Tree Officer Heath & Hampstead Society

2012/5825/P 8 Pilgrims Lane London NW3 1SL

I wish to submit an objection to this application and its latest changes under 4 headings:

GIS Map of Area of potential landslide vulnerability, Based on causative landslide factors; geology, slope angle, hydrology and know landslide activity

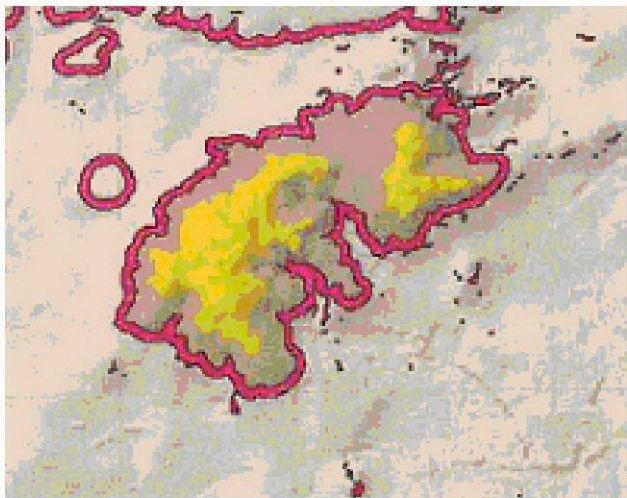
Incidentally the site is right over the 'at risk' area on the GIS Map of Area of potential landslide vulnerability (attached). The calculations made in the Ground Movement Report presuppose the site is completely dry and all ground water disposed of. This is unlikely considering the underlying geology – and as occurred when digging under 22 Christchurch Hill. Here, water under pressure was encountered causing a lake below the development and the neighbouring building to subside considerably. It took 18 months for the incoming water and lake to be controlled, during which time water had to be continually pumped into the waste water system. Slip surfaces within this ground that was compressed and sheered by glaciers during the last ice age – one of the considerations of the GIS Map of Area of potential landslide vulnerability - are not even mentioned.
